May 13, 2016

SUBJECT: PIER 4 PHASE 2 RECONFIGURATION
PROJECT NO. 091251
CONTRACT NO. 070136

ADDENDUM NUMBER SIX

2 DETAIL PILE CUT-OFF AT DOLPHIN
S7.1, S42.1 3/4"=1'-0"

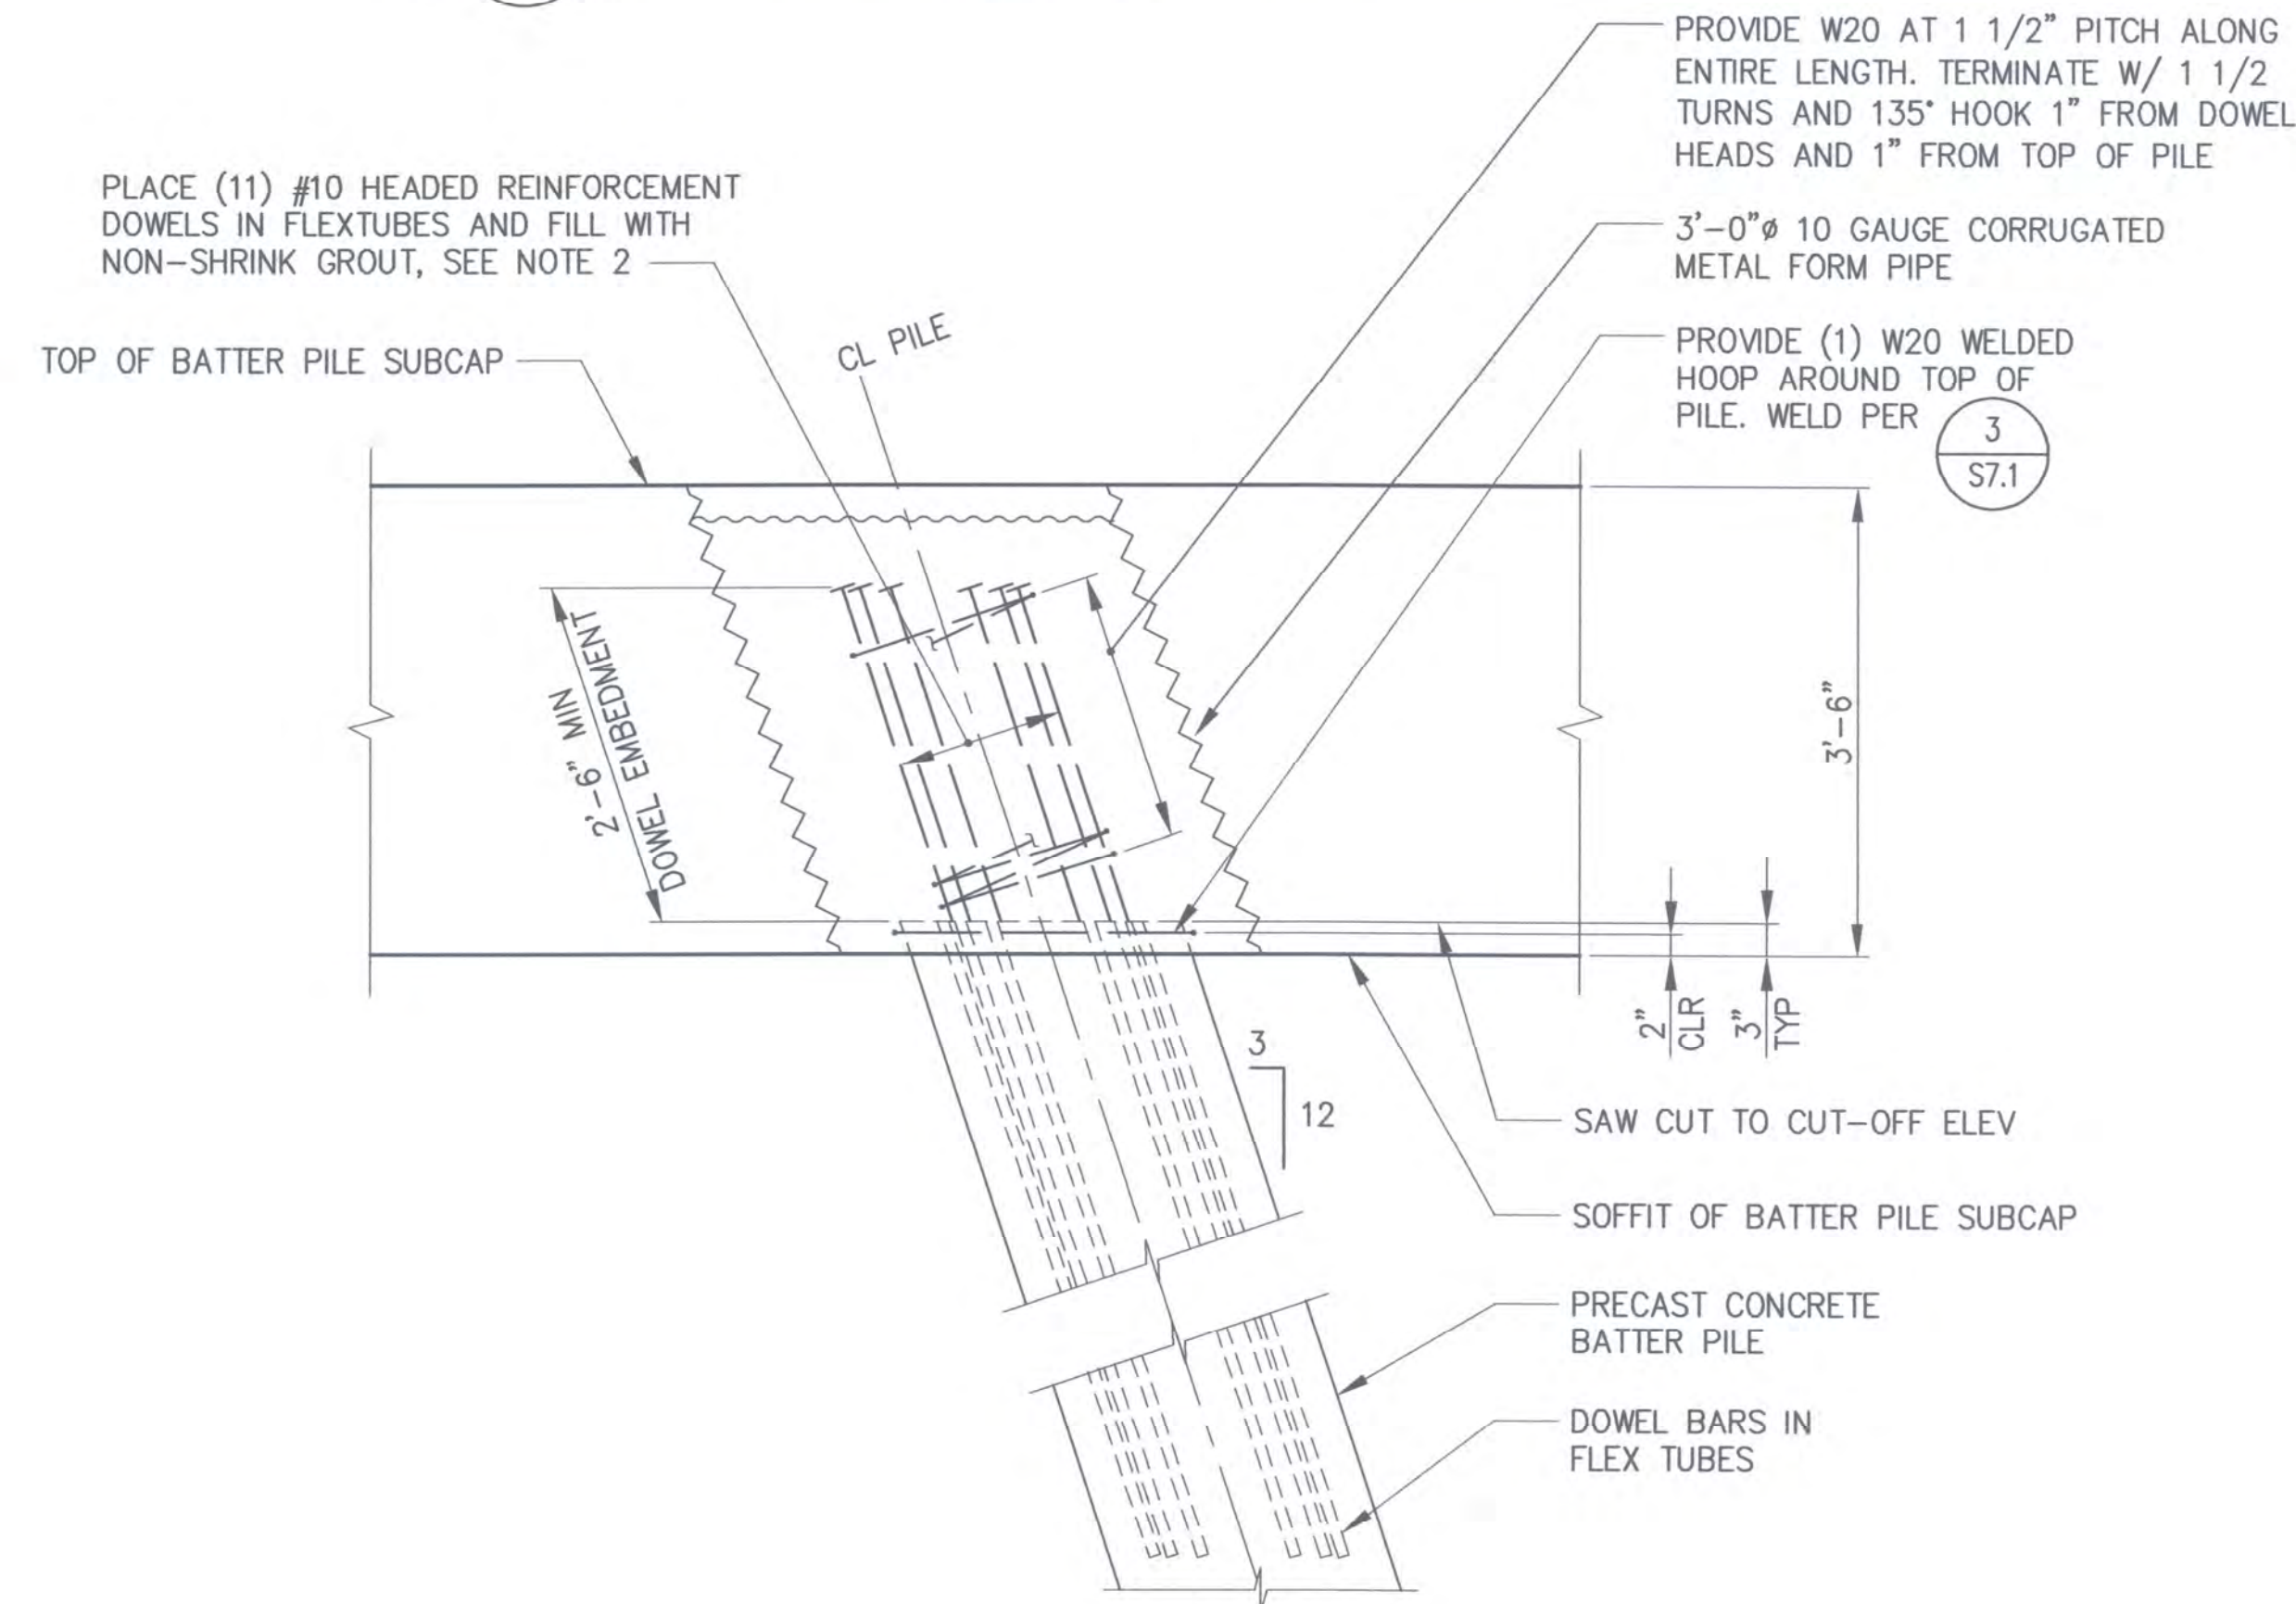
1. **REVISE** Detail 3 Spiral Details as denoted. (See Attachment H to this Addendum No. 6)
